Title:	Plate Detection on Transfer Station			ID:
				0168
Date in:	Response:	Model:	Author:	
2004-07-15	2004-07-15	LPX44	CMa

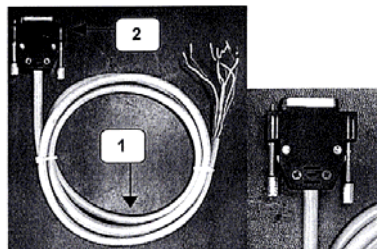
Have some strange activity with a LPX 44...

It seems like the sensor on the transfer station does not let a plate be placed until it is "active". The handler will wait until I place my hand over the transfer station sensor, then it will deliver.

We had corrected this one time by a quick power cycle, but that is not working now. Mark, Can you provide the serial number?

Is it possible that the sensor is wired to the end switch input of the active transfer station? You can check this by "RD 100" or "RD 101". The correct inputs of the transfer station sensors are 102 and 103. The sensor should read '1' when covered on "RD 1813" or "RD 1807".

You may also check 3210 "RD 3210". This flag is set to '1' after initialisation when the system detects an active transfer station.
